**CITY OF BATON ROUGE
PARISH OF EAST BATON ROUGE**

ADDENDUM NO. 2

**SUBJECT: TERRACE AVENUE (Highland Road – Perkins Road) PROJECT
CITY-PARISH PROJECT NO. 20-EN-HC-0045**

GENERAL NOTES

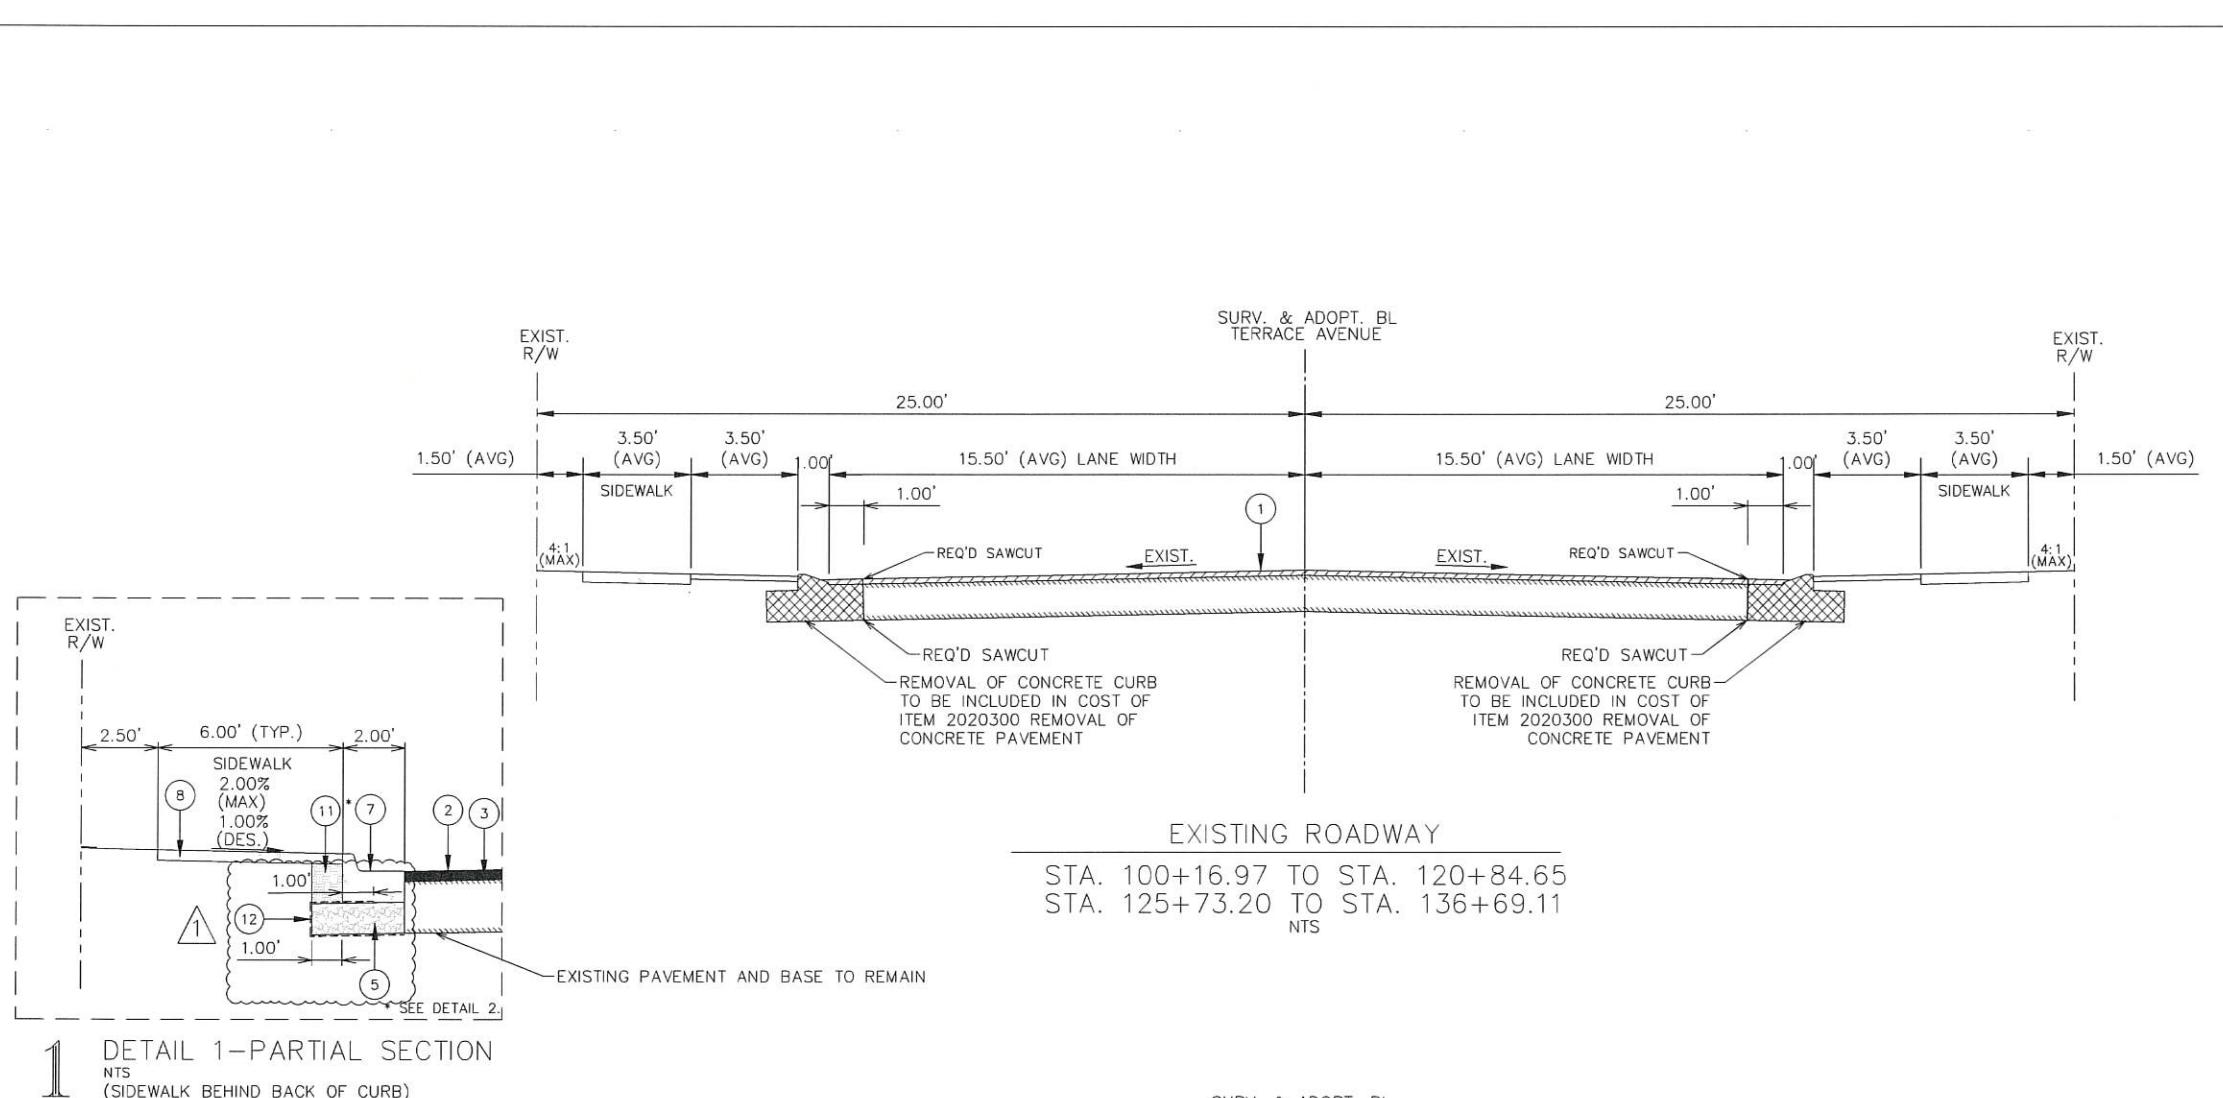
- **No Davis Bacon Wages Rates or any certified wage rates are required for this project.**
3. On Sheet 1e, it says Item 1152108 is to include base course but on sheet 3a, it says base course is to be paid under a separate item. Please advise.

- **Please see the revised drawing sheets 1e and 3a for your information and use.**
4. Is fabric required under the base course as the detail shows no fabric and there is no note.

TYPICAL SECTIONS
(TERRACE AVENUE)

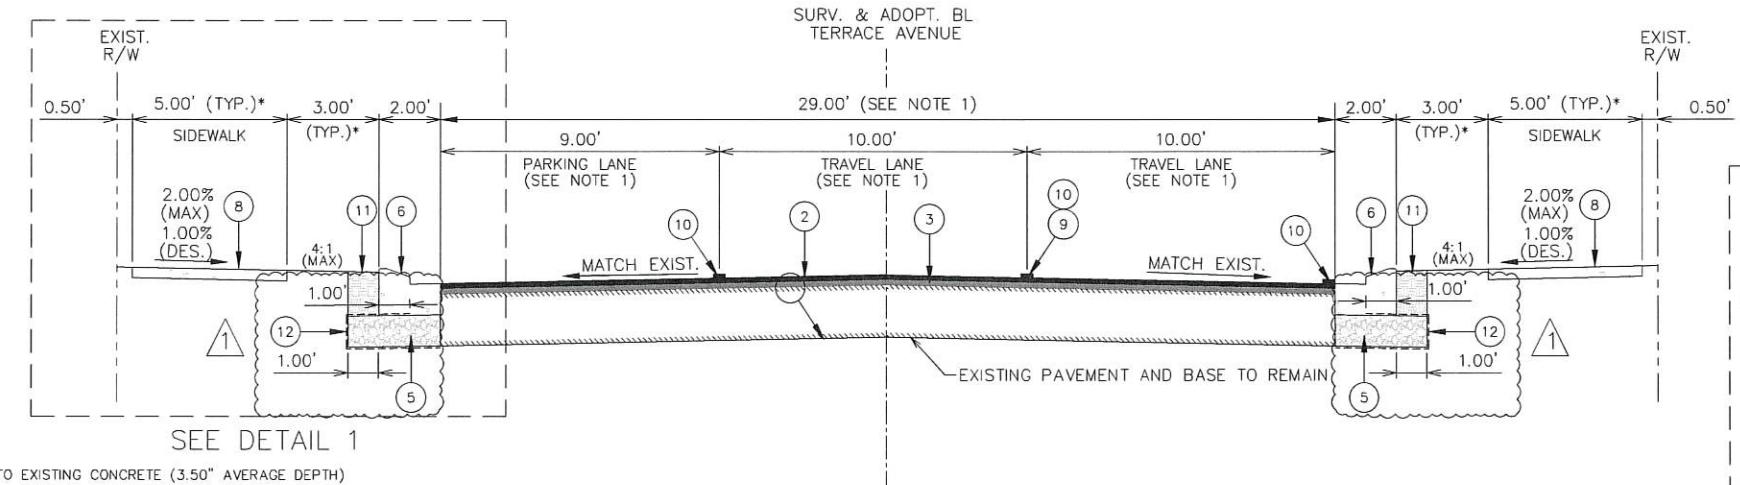
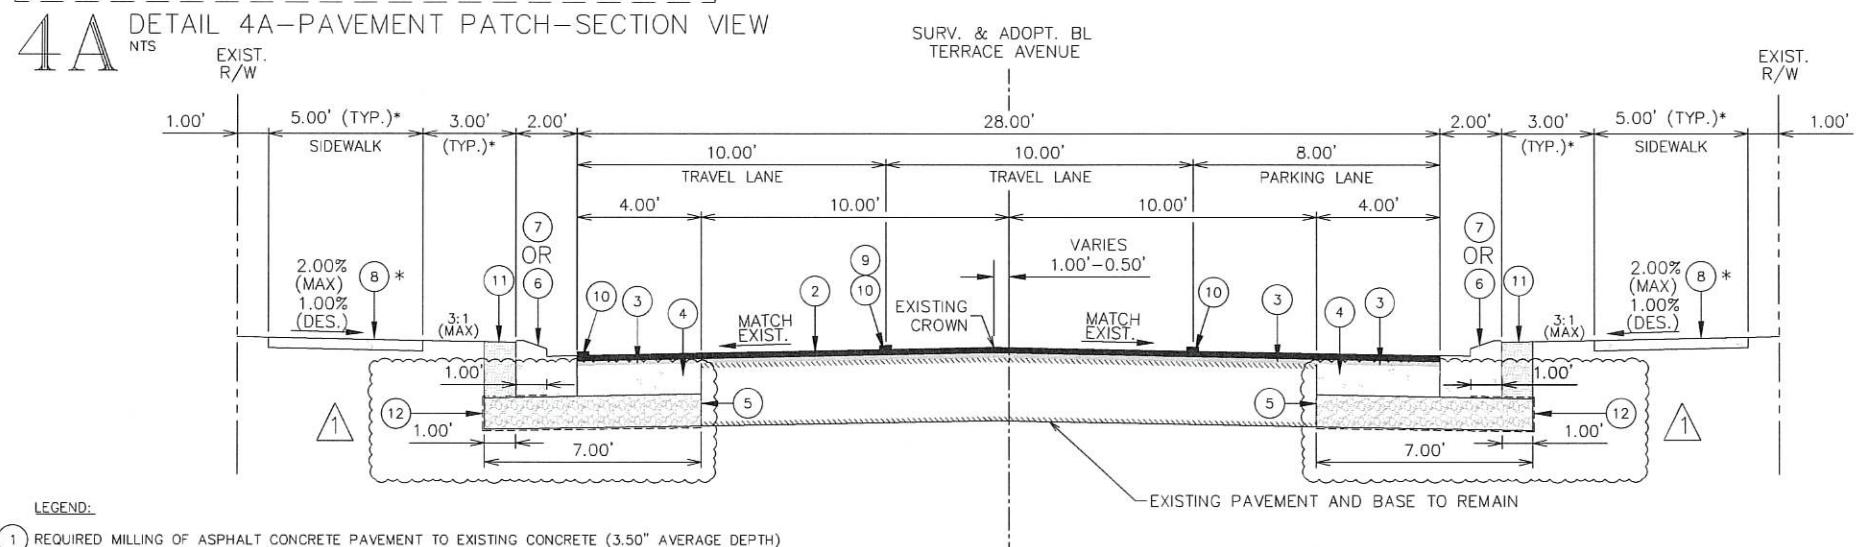
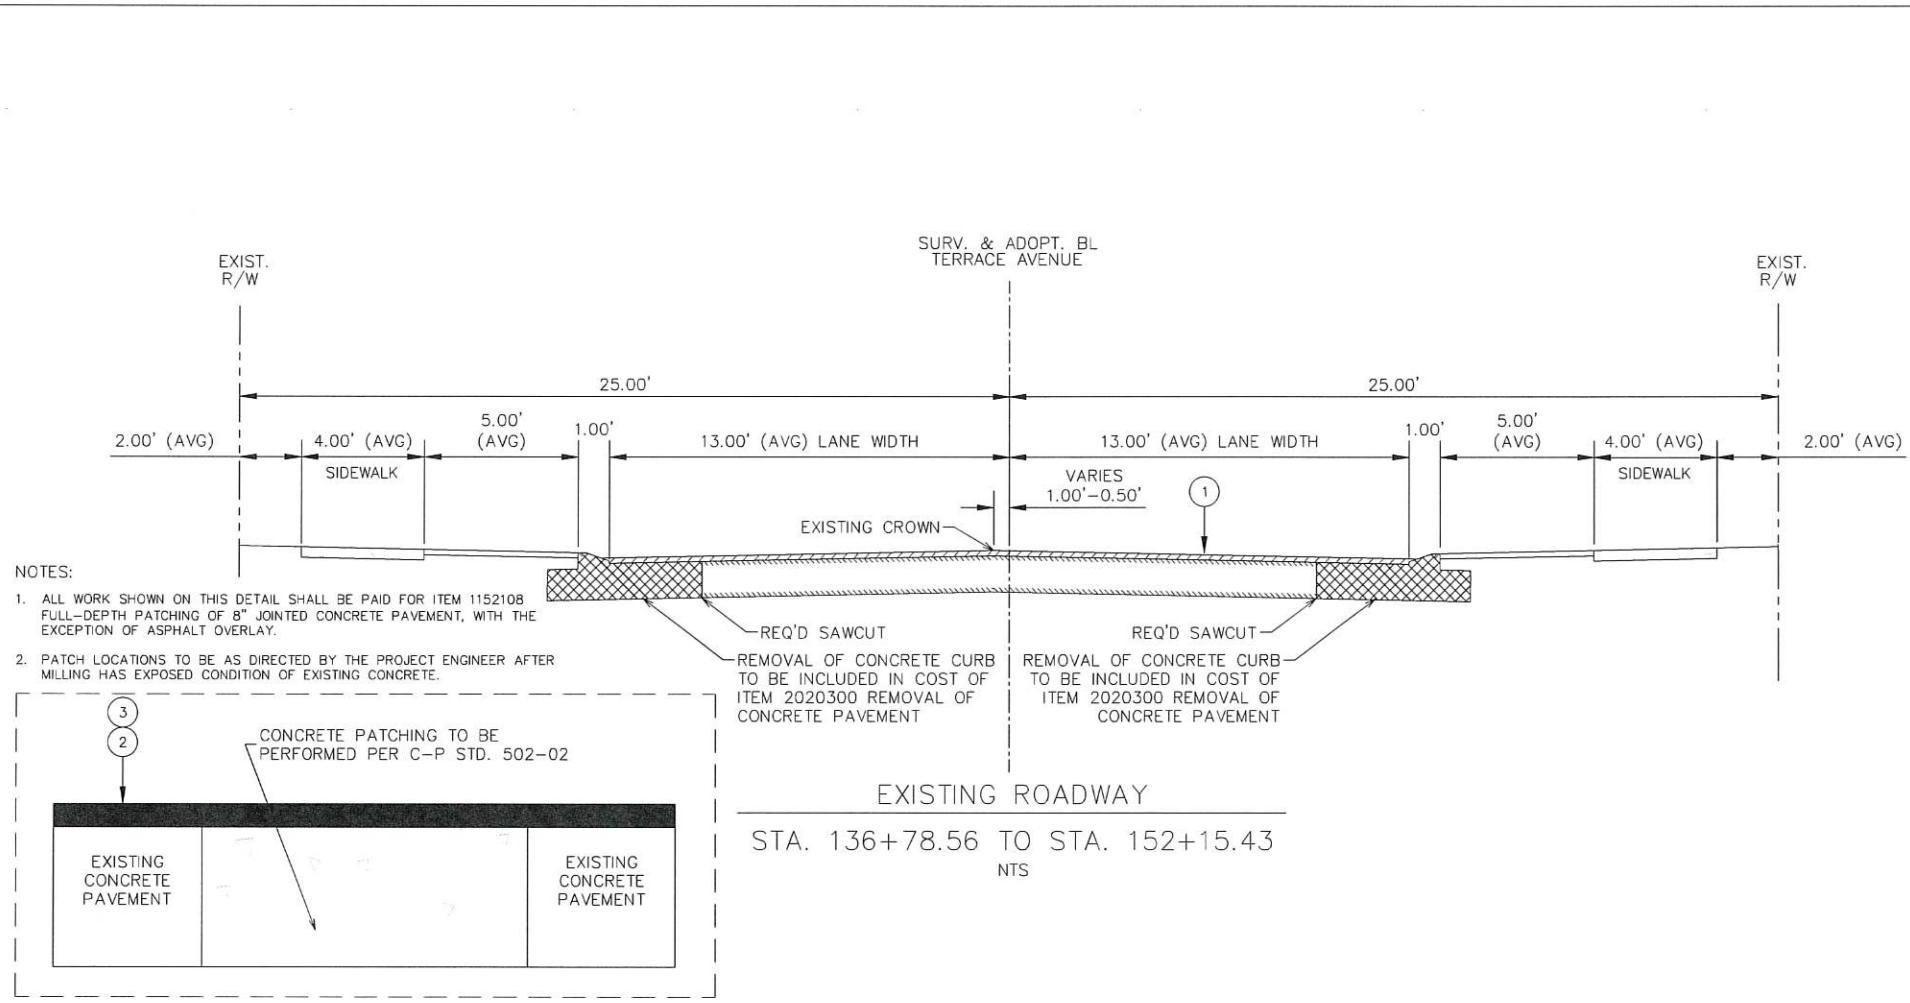
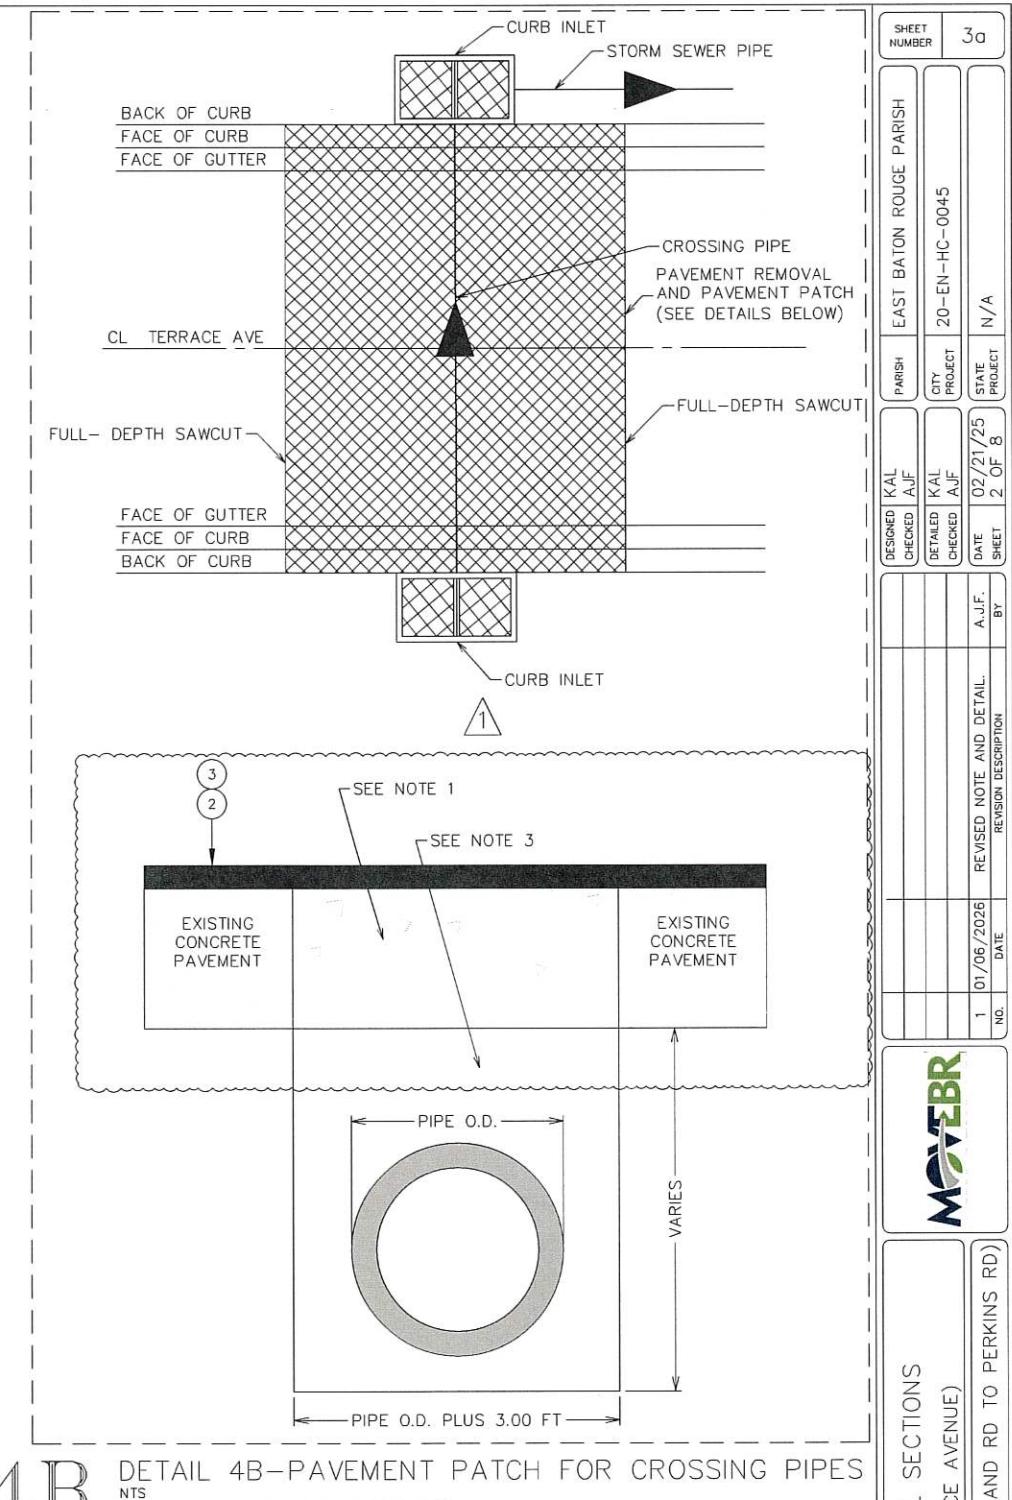
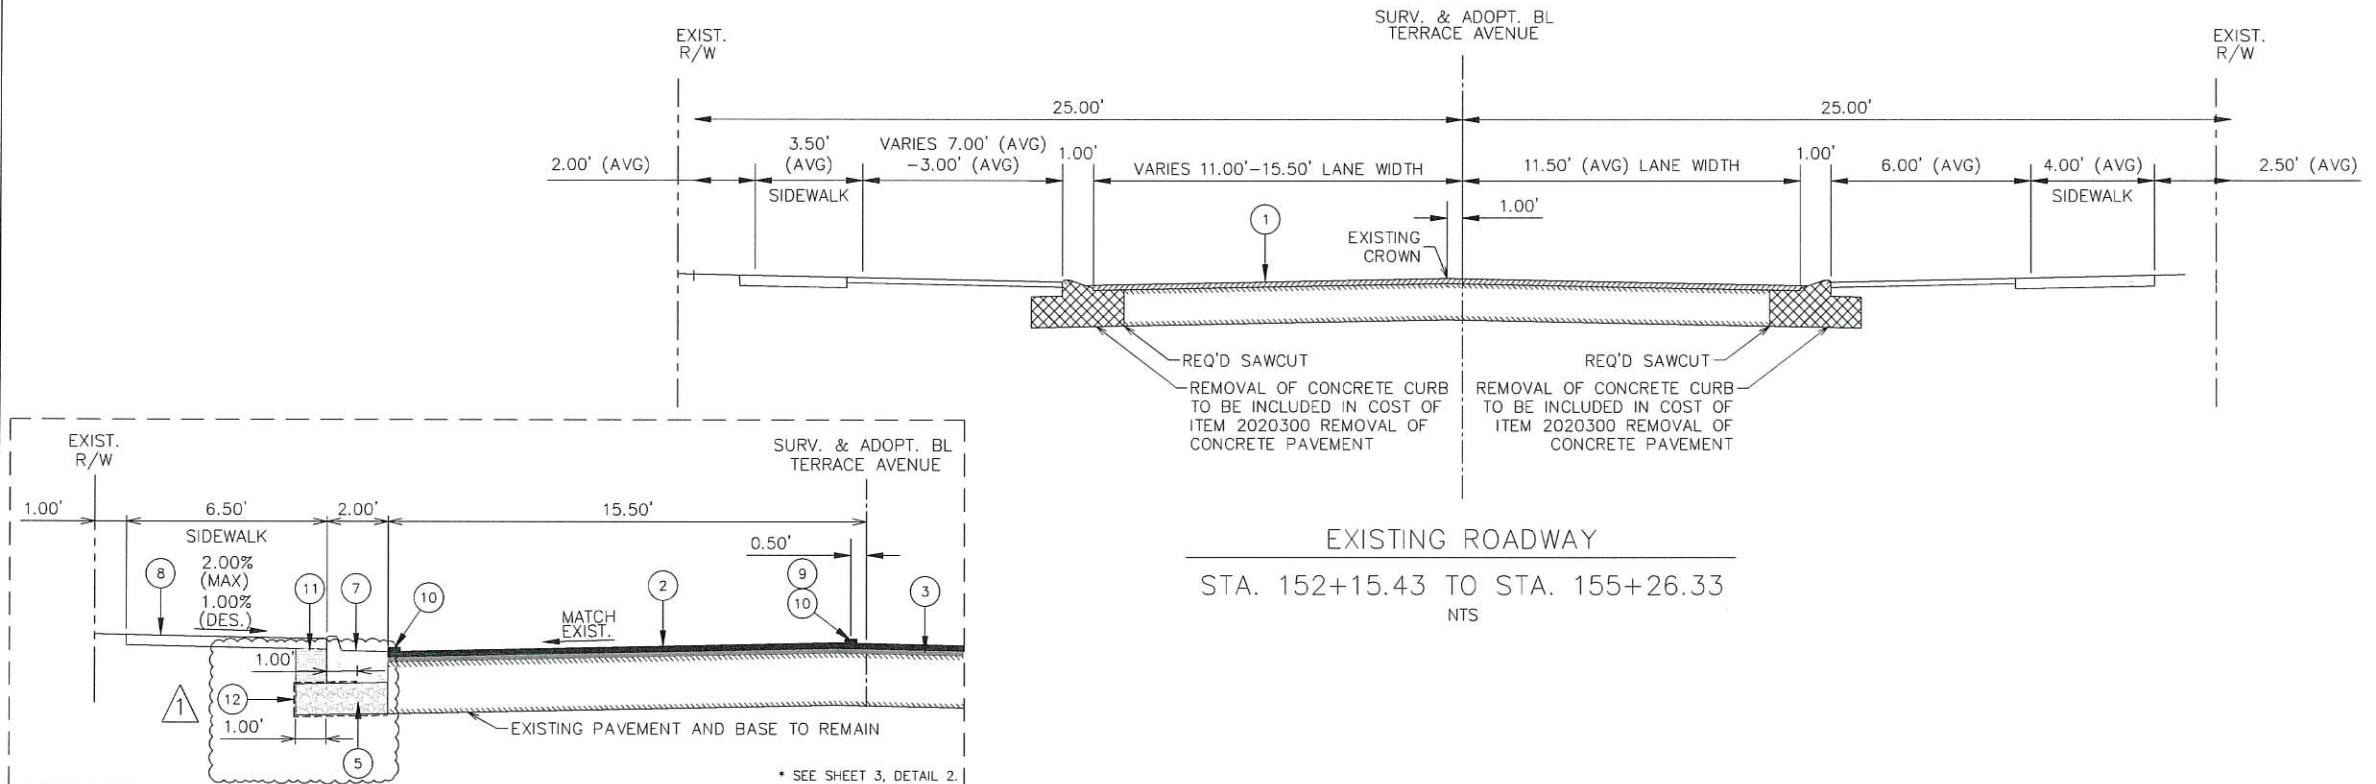
- **The revised drawings (see Sheets 3, 3a, & 3b) are attached showing the fabric under the base course.**
5. Is railroad insurance required on this project as stated in the Special Provisions Section 7.6? If so, please provide the crossing number for our railroad insurance quote.
